Planning and Zoning Board Agenda July 9, 2019

- A. Approval of the Minutes of the June 11, 2019 PZB Meeting
- B. Site Plan - Alchem Building Three: A request by Caitlyn Drane, P.E. of eda engineers-surveyors-

- C. Site Plan - Innovation One: A request by Alison Fetner, P.E., of Fetner Engineering, applicant and agent for Shoppes at Progress Center, LLC, property owner, for consideration of a Site Plan to construct a ±30,676 square foot light manufacturing (research and development) facility, with associated paving, grading, drainage, landscaping and infrastructure improvements, on a ±2.80 acre subject property, located southwest of the intersection of US Highway 441 and Progress Boulevard, and north of Research Drive and UF Innovate | Sid Martin Biotech; Tax Parcel Number 03956-010-027 (Quasi-Judicial Hearing).

SUBJECT: Site Plan - Alchem Building Three: A request by Caitlyn Drane, P.E. of eda engineers-surveyors-planners, inc., applicant and agent for James D. Talton of Alchem Laboratories Corporation, property owner, for consideration of a Site Plan to construct a ±12,000 square foot light manufacturing facility, with associated paving, grading, drainage, landscaping and infra

AC&D File Name		Project:		Sheet Scale: 1" = 30'		Approved By:	
				Project No:		Title:		Sheet Scale: n/a			
				19-06						ALISON FETNER, PE 44669	
				C-2		UTILITY PLAN		Date:			
								JAN, 2019

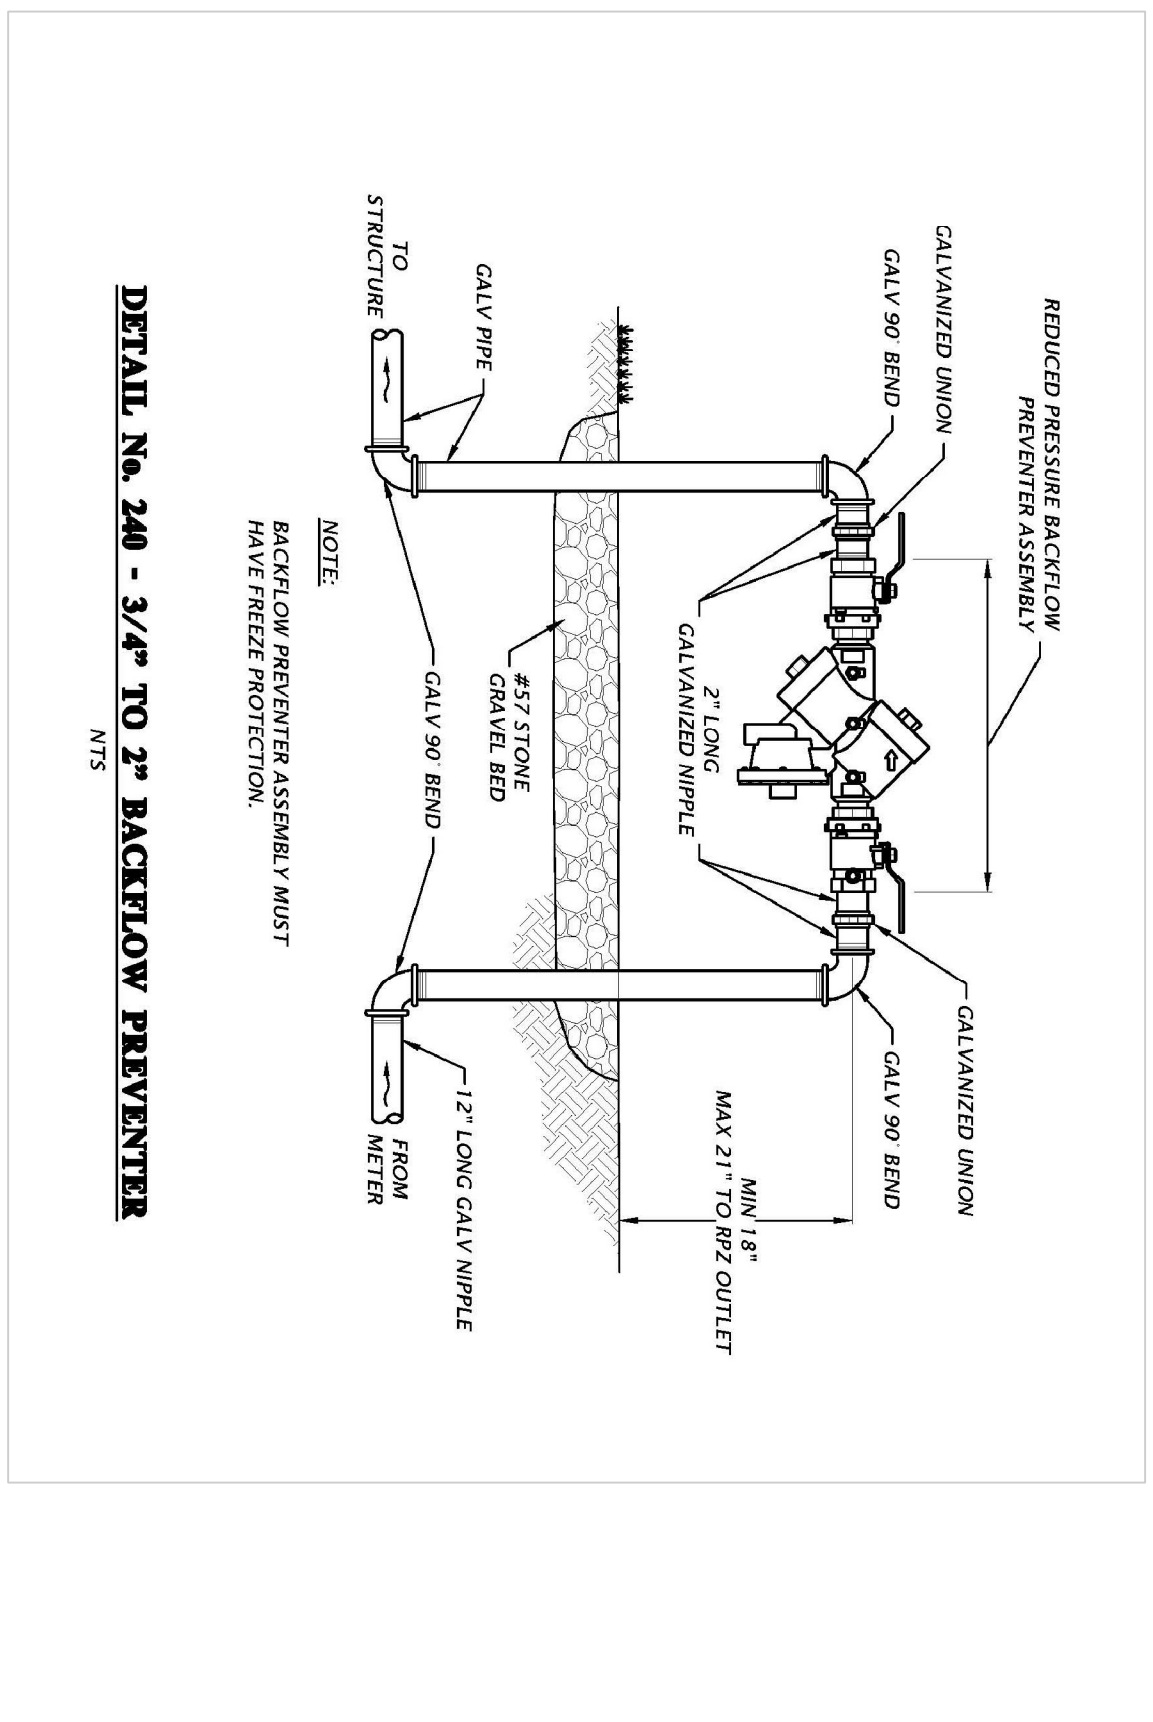
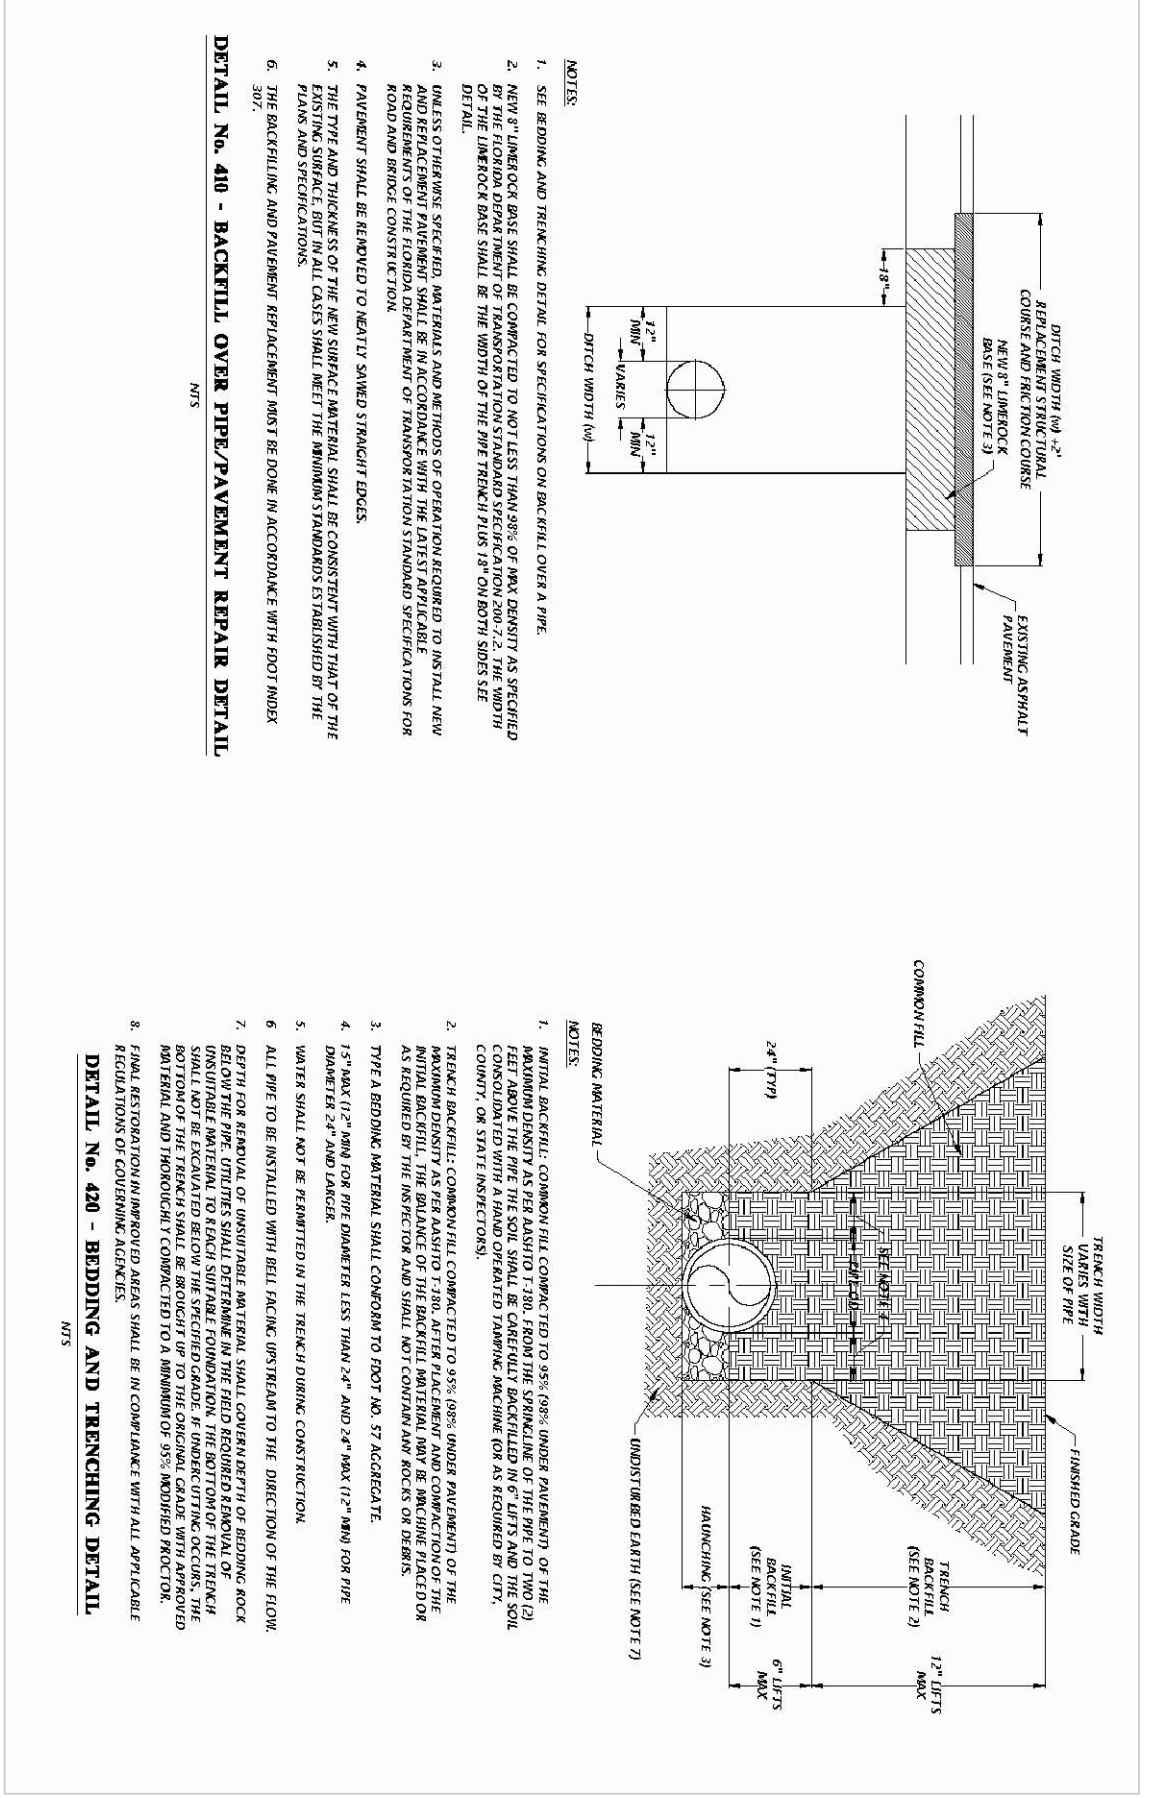
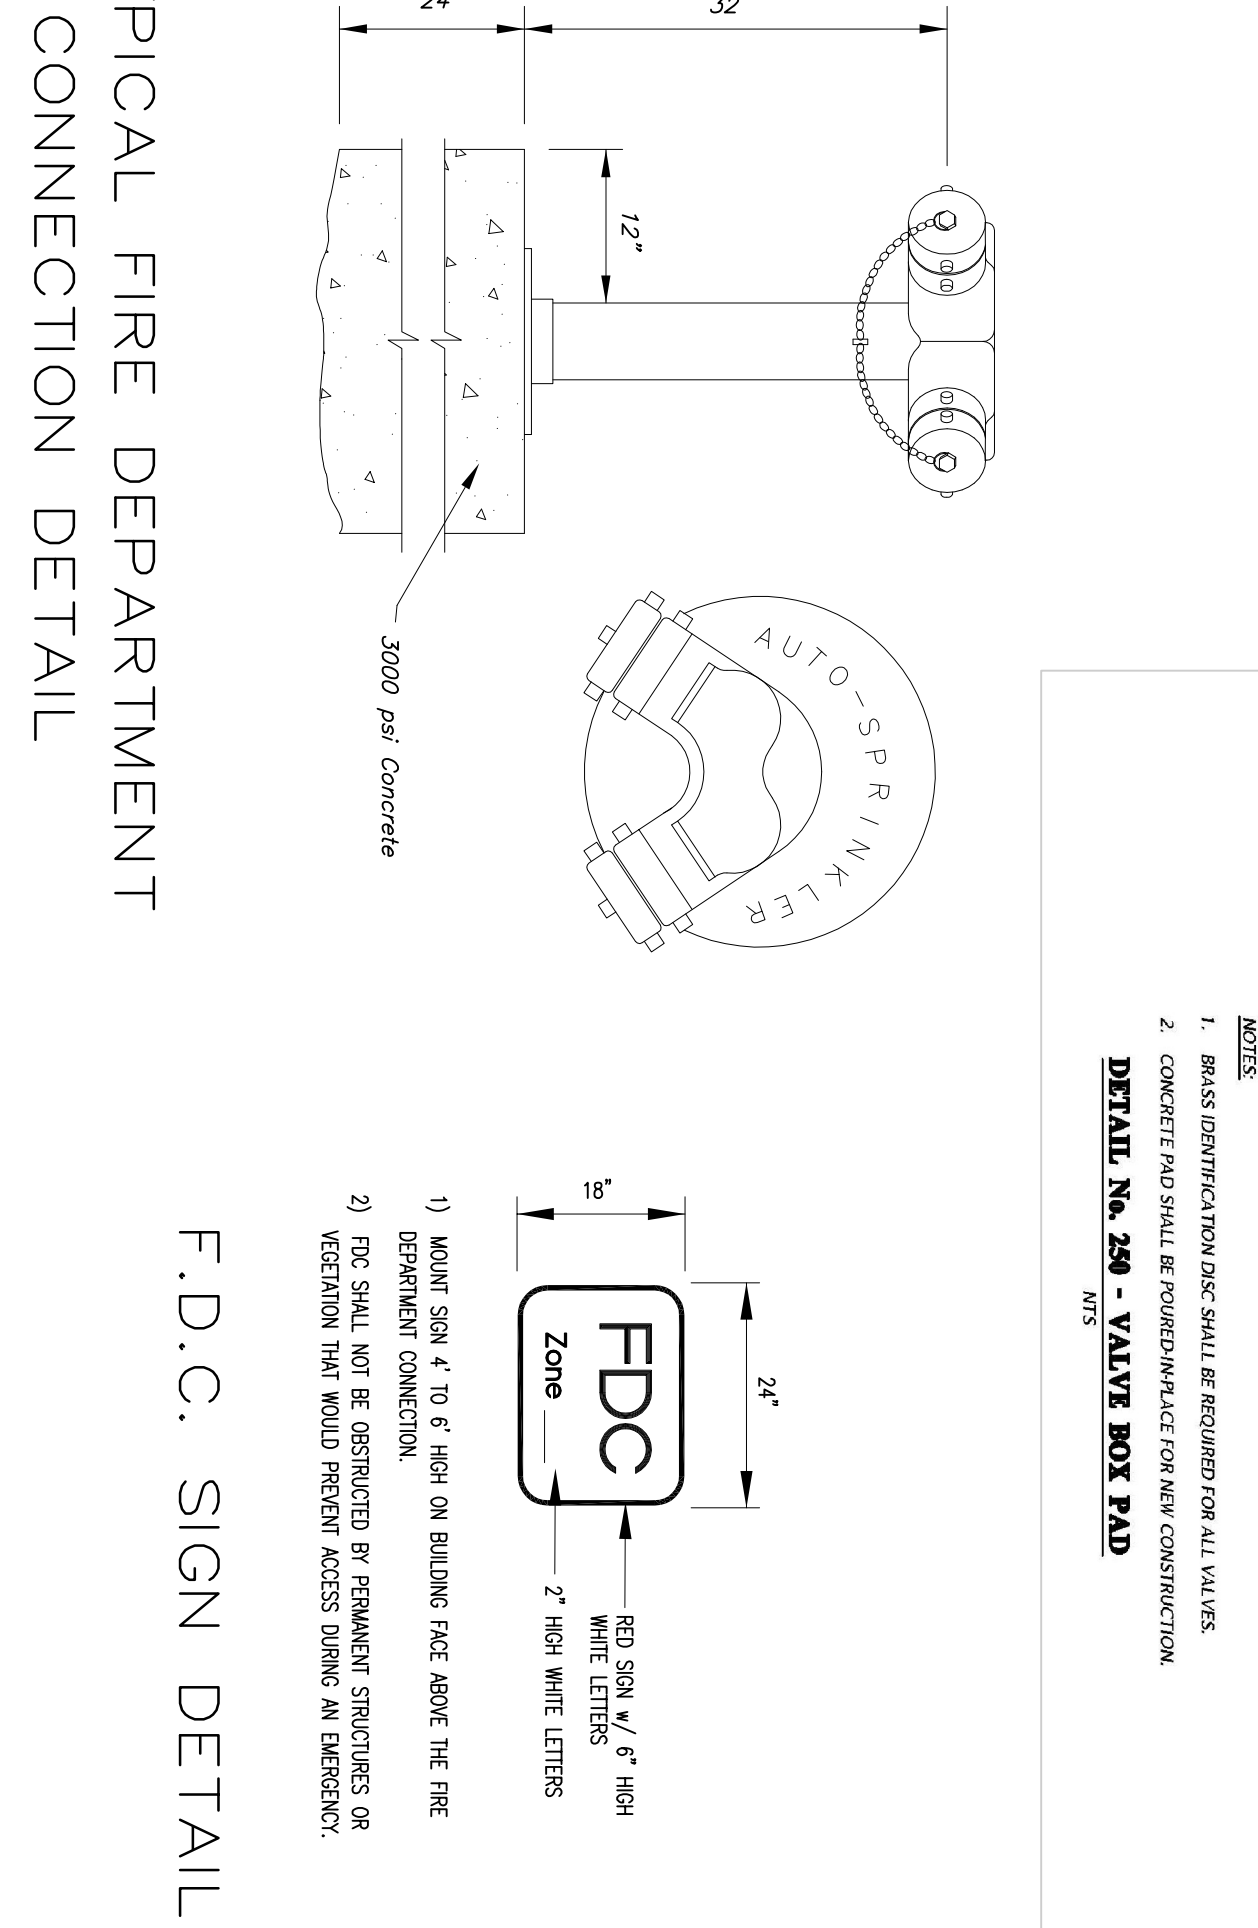
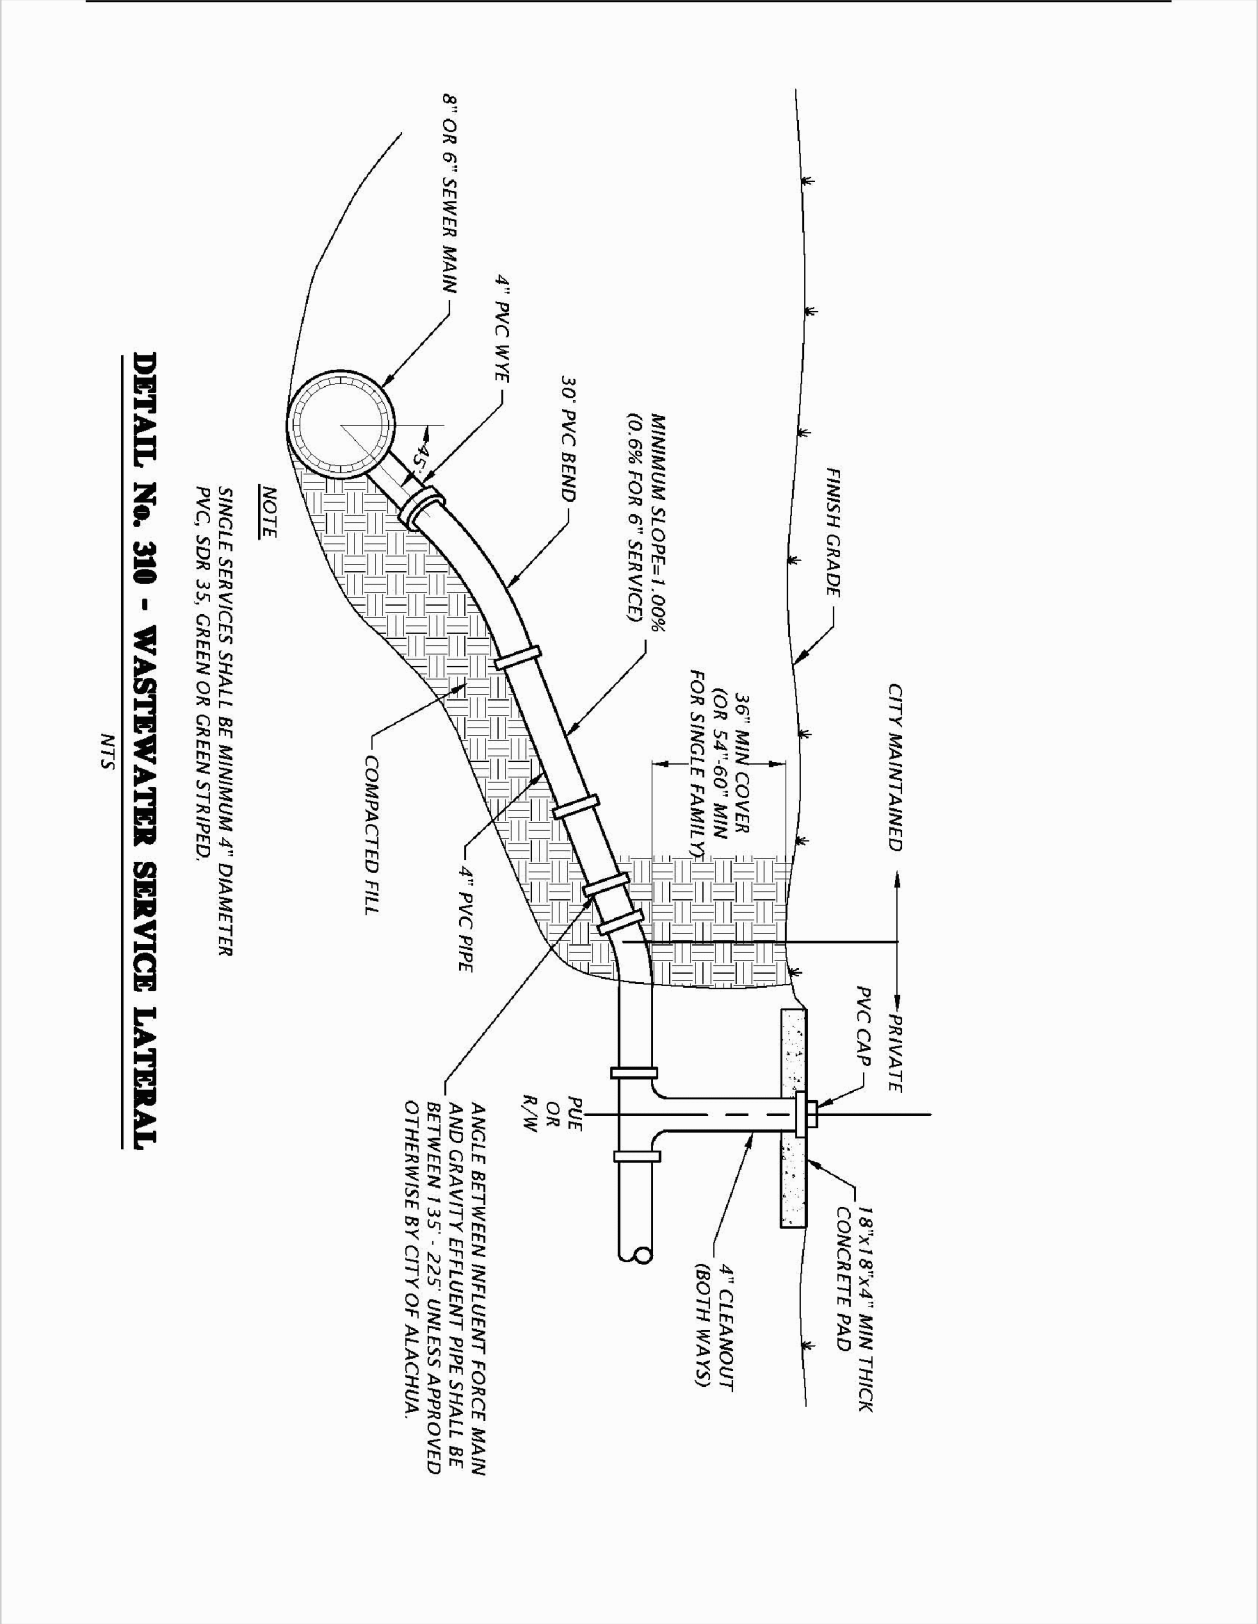
Sheet C-2 Utility Plan, Fire Line and Ganged Water Meters

As now shown there is one common RPZ backflow preventer for the fire line and ganged water meters. Please provide individual RPZ backflow preventers and isolation valves for the fire line and ganged water meters. For the ganged water meters, suggest using Detail 240 – please add to C-3.

4.	Sheet I, Survey Add sheet number and title to this sheet. [Approved as Noted] Comments for April 29th Submittal Approved.
5.	Sheet C-2, Utility Plan - A 4-inch lateral line (just below text “Terminus of 4-inch PVC fire protection line” appears to be missing a segment. Please add. - Add leader to text “4-inch PVC lateral (type)”. - Last page of report indicates that an on-site dumpster will be provided. Please call out this dumpster. - A 4-inch backflow preventer (BFP) is shown in the water line. Please add a detail for this BFP in detail sheet(s). - A segment of the 1-inch water line runs underneath the road. Is there any way to reroute it so its route under the road is minimized. - Please confirm that no electrical work is part of this project. [Revise and Resubmit] Comments for April 29th Submittal Approved.

6.	Sheet C-2, Utility Plan - Show easements for City maintained facilities. - Cleanouts (wastewater) and water meters are shown just south the proposed building. These components will need to be accessed by City staff once construction is complete. Locate City utilities (i.e. wastewater cleanout and water meter) within the Public Utility Easement (PUE). - The reviewer assumes this PUE is south of the “Northerly Right of Way Line- Research Drive”, Sheet S-1. Please confirm. - Locating these components in the PUE will require that pipe routing be changed for both water and wastewater. [Revise and Resubmit]

NO.	COMMENTS
4.	Sheet 1, Survey Add sheet number and title to this sheet. [Approved as Noted]
5.	Sheet C-2, Utility Plan • A 4-inch lateral line (just below text "Terminus of 4-inch PVC fire protection line" appears to be missing a segment. Please add. • Add leader to text "4-inch PVC lateral (type)". • Last page of report indicates that an on-site dumpster will be provided. Please call out this dumpster. • A 4-inch backflow preventer (BFP) is shown in the water line. Please add a detail for this BFP in detail sheet(s). • A segment of the 1-inch water line runs underneath the road. Is there any way to reroute it so its route under the road is minimized. • Please confirm that no electrical work is part of this project. [Revise and Resubmit]

6.	Sheet C-2, Utility Plan • Show easements for City maintained facilities. • Cleanouts (wastewater) and water meters are shown just south the proposed building. These components will need to be accessed by City staff once construction is complete. Locate City utilities (i.e. wastewater cleanout and watermeter) within the Public Utility Easement (PUE). • The reviewer assumes this PUE is south of the "Northerly Right of Way Line- Research Drive", Sheet S-1. Please confirm. • Locating these components in the PUE will require that pipe routing be changed for both water and wastewater. [Revise and Resubmit]
